Product Change Notification

Product Change Notification: PCN-26-289679

AM WIRE PIN 20-17 .013 BR

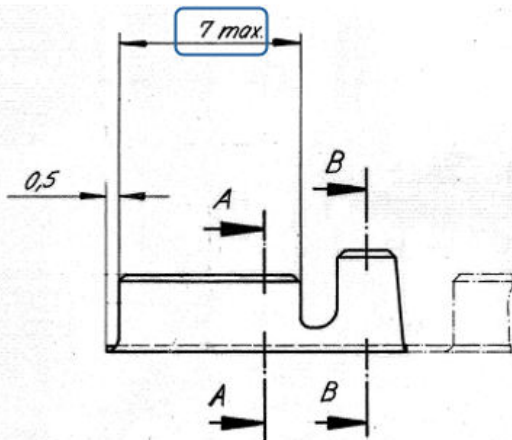
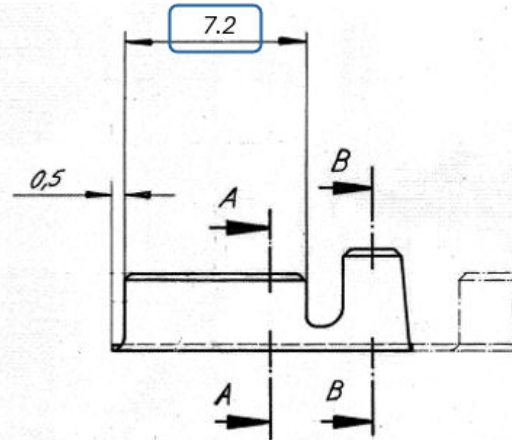
Dear valued Customers, to support long-term product availability and maintain a robust manufacturing process, selected dimensions have been updated. The updated drawing continues to meet the specified functional and performance requirements of the product

Dimension was 7mm Max

Dimension updated to 7.2mm

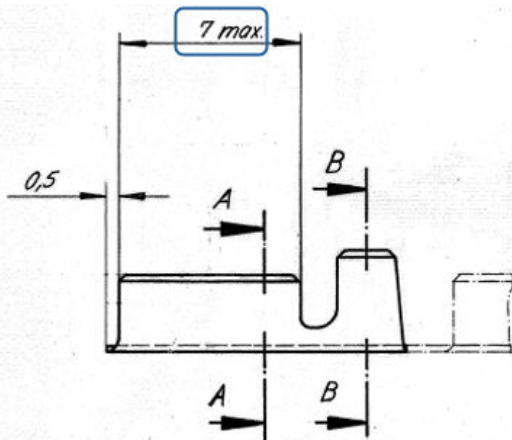
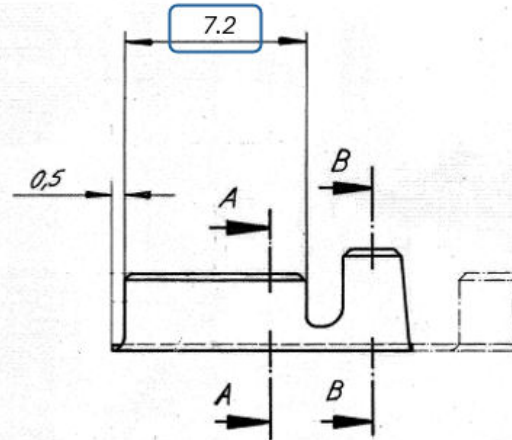
Dear valued Customers, to support long-term product availability and maintain a robust manufacturing process, selected dimensions have been updated. The updated drawing continues to meet the specified functional and performance requirements of the product

Dimension was 7mm Max

Dimension updated to 7.2mm
